CITY OF DULUTH

Addendum 2

File 19-05AA

RFP Develop and Implement an Energy Service Micro-Grid System

Motor Control Cabinet for High Lift Pump 1

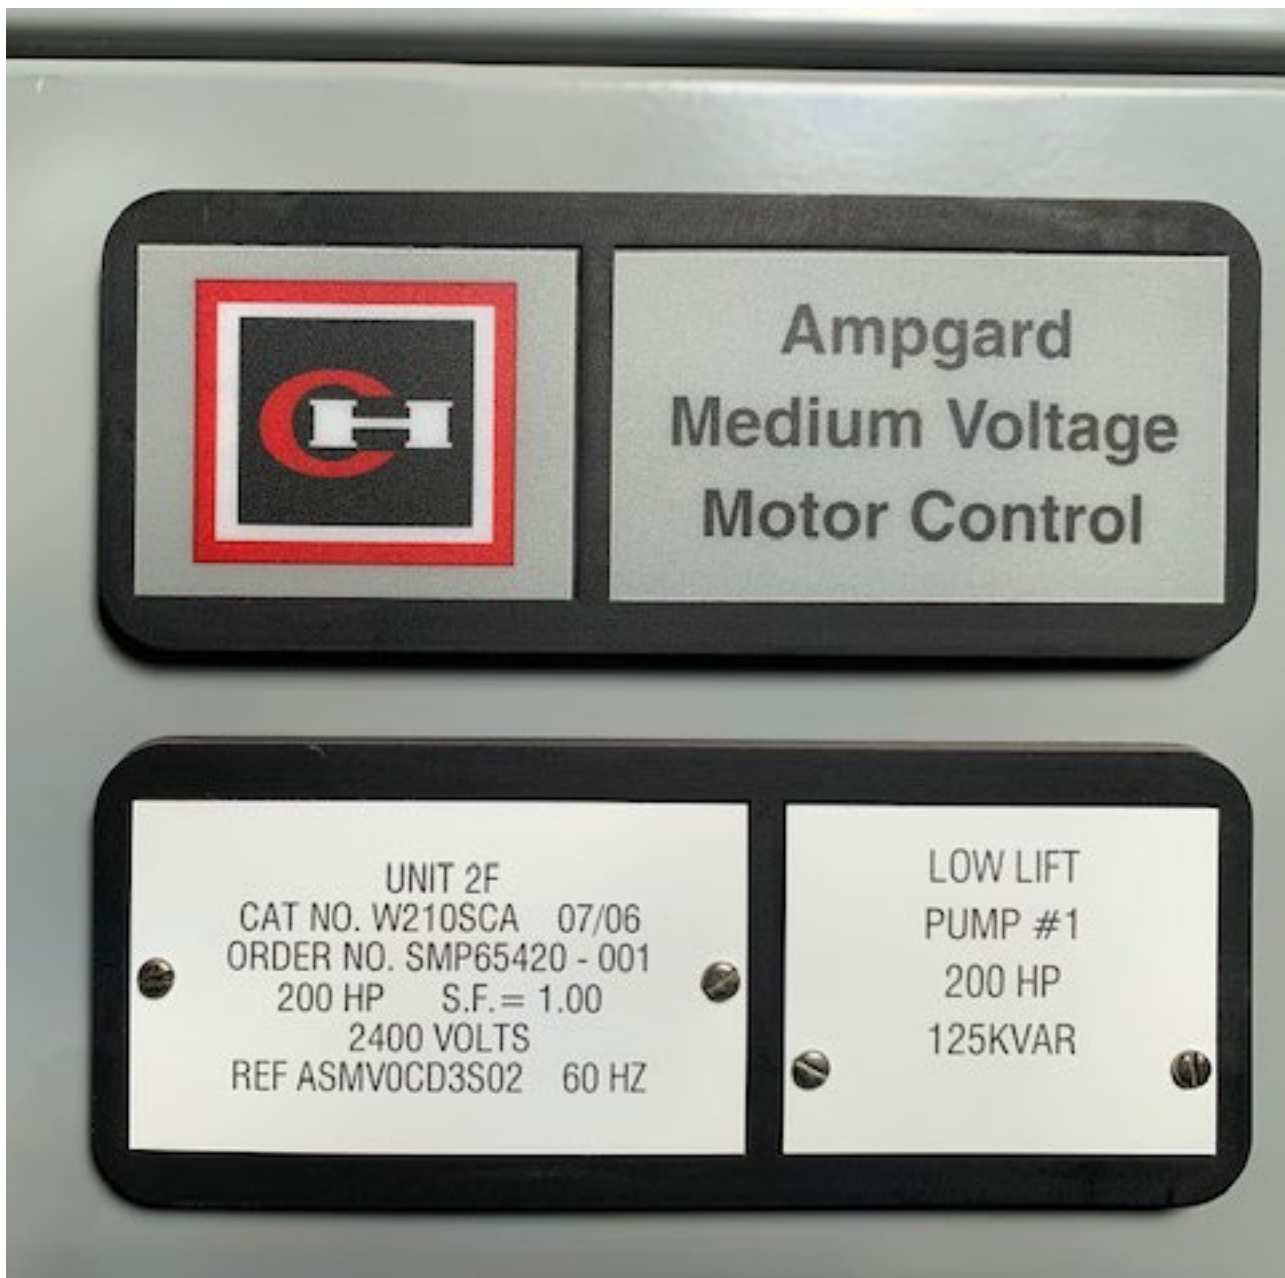
23. Photos of the name plates for low lift pump 1, high lift pump 1, transformer for the pumps, motor control cabinet high 1 and low 1 are attached.

Transformer for Pumps

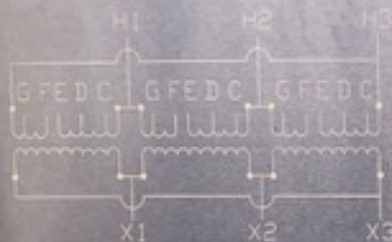
9. Please provide details on the existing step-down transformer, including make, model, ratings, location, age, etc.
Please see the attached photo of the name plate.
